Contract #: 04-0120F4Cty: SF/ALA Rte: 80 PM: 13.2/13.9File #: 69.25B**QUALITY ASSURANCE -- NON-CONFORMANCE REPORT****Location:** Changxing Island, Shanghai, P.R. China**Report No:** NCR-000947**Prime Contractor:** American Bridge/Fluor Enterprises, a JV**Date:** 15-Dec-2010**Submitting Contractor:** Zhenhua Port Machinery Company, Ltd (ZPMC), Changxing Island**NCR #:** ZPMC-0906**Type of problem:**

Welding	Concrete	Other	
Welding	Curing	Procedural	Bridge No: 34-0006
Joint fit-up	Coating	Other	Component: Traveler Rail 20TR2-048
Procedural	Procedural	Description: 10 Missed MT indication by QC

Reference Description: QA found 10 missed MT indications after ZPMC had tested and accepted the weld (battered base metal) on the Traveler Rail

Subject: NCR No. ZPMC-0906

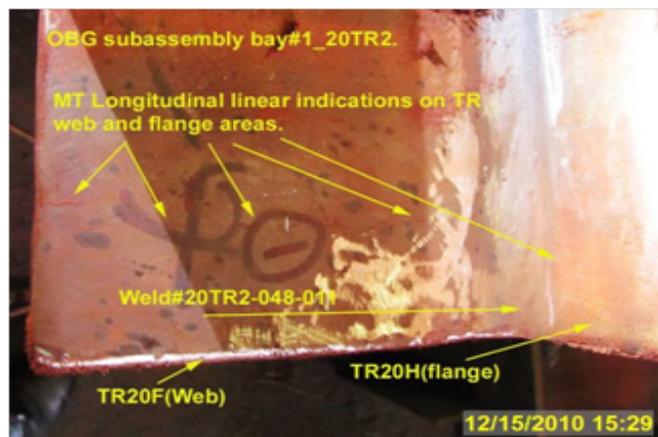
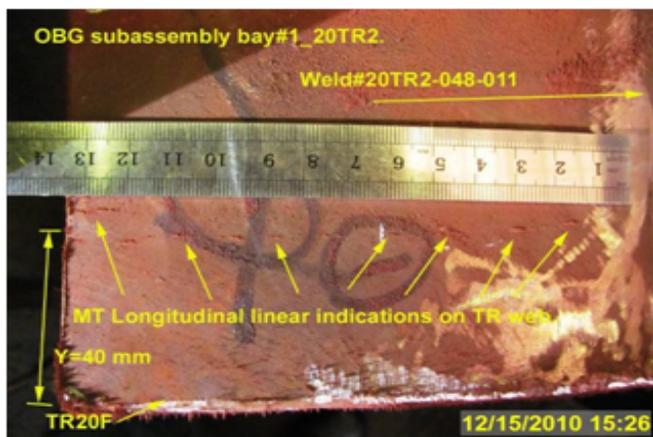
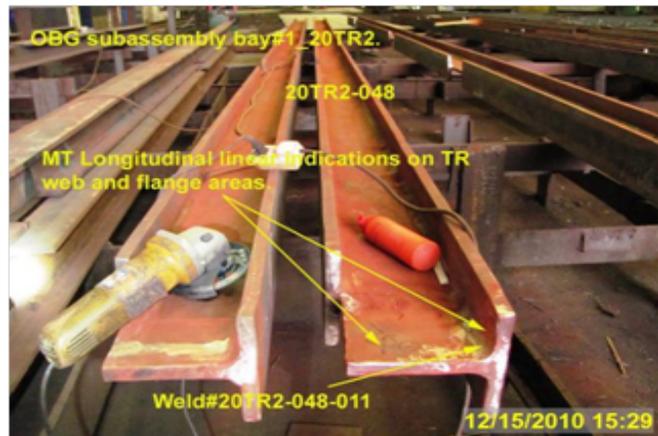
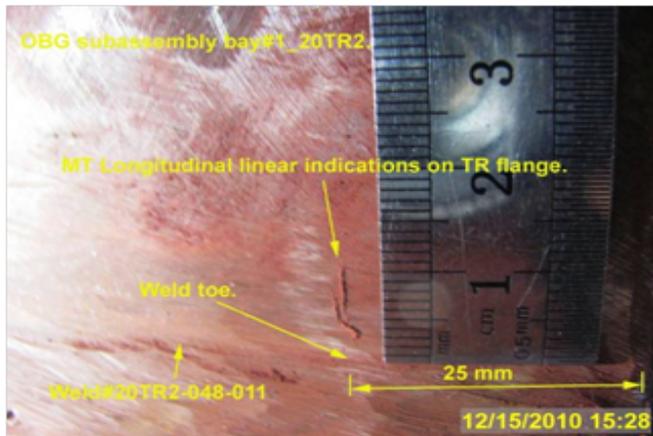
During Quality Assurance (QA) Magnetic Particle Testing (MT) review of welds located on Orthotropic Box Girder (OBG) Traveler rail (TR) 20TR2-048, this QA Inspector discovered the following issue:

- 10 linear indications measuring approximately 4 ~10 mm in length were found on this traveler rail.
- The indications are located at the base metal of the web and flange, and the battered areas at the end of the traveler rail.

- The nearest weld is identified as: 20TR2-048-011.
- The web and flange are identified as TR20F and TR20H respectively.
- The "Y" locations of the indications are approximately 40 mm and 25 mm for web and flange, respectively.

- The "Y" locations are measured from the end of the traveler rail as shown in the photos below.
- The thickness of the TR web and flange is 20 mm.
- Traveler rail 20TR2-048 is currently located in the OBG Sub assembly Bay #1.

- The Notice of Witness Inspection Number (NWIT) is 07789. The indications are located within the area that has been previously tested and accepted by ZPMC Quality Control (QC) personnel. As per the contract documents, ZPMC QC personnel are required to perform 100% MT inspection of these welds and battered locations.

Reference Resolution: ZPMC has repaired the indication noted in the NCR and is providing NDT documentation after the repair to show the indication has been removed.

ZPMC has repaired the indication noted in the NCR and is providing NDT documentation after the repair to show the indication has been removed. ABFJV has noted which inspector was responsible for this missed indication and is monitoring his performance as well as all inspector performance, if he continues to miss indications disciplinary action will be undertaken. Based on these actions, ZPMC requests closure of this NCR.

The proposed resolution is acceptable. This NCR is considered closed.

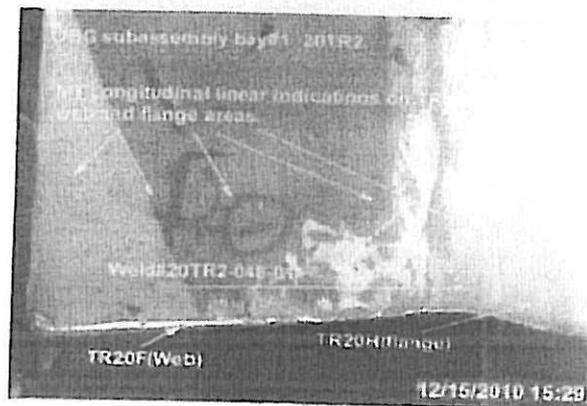
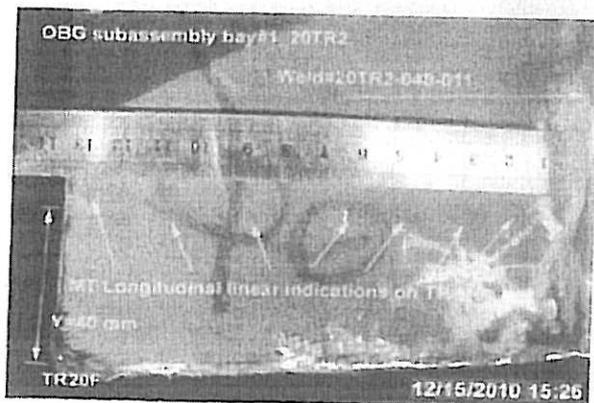
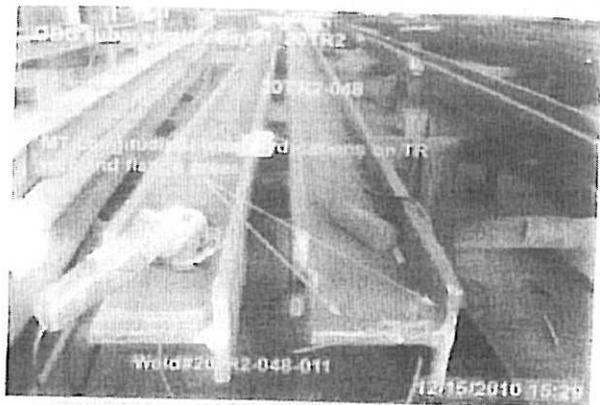
During Quality Assurance (QA) Magnetic Particle Testing (MT) review of welds located on Orthotropic Box Girder (OBG) Traveler rail (TR) 20TR2-048, this QA Inspector discovered the following issue:

- 10 linear indications measuring approximately 4 ~10 mm in length were found on this traveler rail.
- The indications are located at the base metal of the web and flange, and the battered areas at the end of the traveler rail.

- The nearest weld is identified as: 20TR2-048-011.
- The web and flange are identified as TR20F and TR20H respectively.
- The "Y" locations of the indications are approximately 40 mm and 25 mm for web and flange, respectively.

- The "Y" locations are measured from the end of the traveler rail as shown in the photos below.
- The thickness of the TR web and flange is 20 mm.
- Traveler rail 20TR2-048 is currently located in the OBG Sub assembly Bay #1.

- The Notice of Witness Inspection Number (NWIT) is 07789. The indications are located within the area that has been previously tested and accepted by ZPMC Quality Control (QC) personnel. As per the contract documents, ZPMC QC personnel are required to perform 100% MT inspection of these welds and battered locations.

Contractor will repair the welds, and perform NDT to prove the welds are acceptable. Contractor will identify and issue an internal NCR to the inspector who missed the indications. Contractor will monitor his performance. Disciplinary action will be taken if the inspector misses indications continuously.

Contractor repaired the weld and performed NDT subsequently. NDT report shows that the welds are acceptable. Contractor identified and issued an internal NCR to the inspector who missed the indications. Contractor is monitoring the inspector's performance.
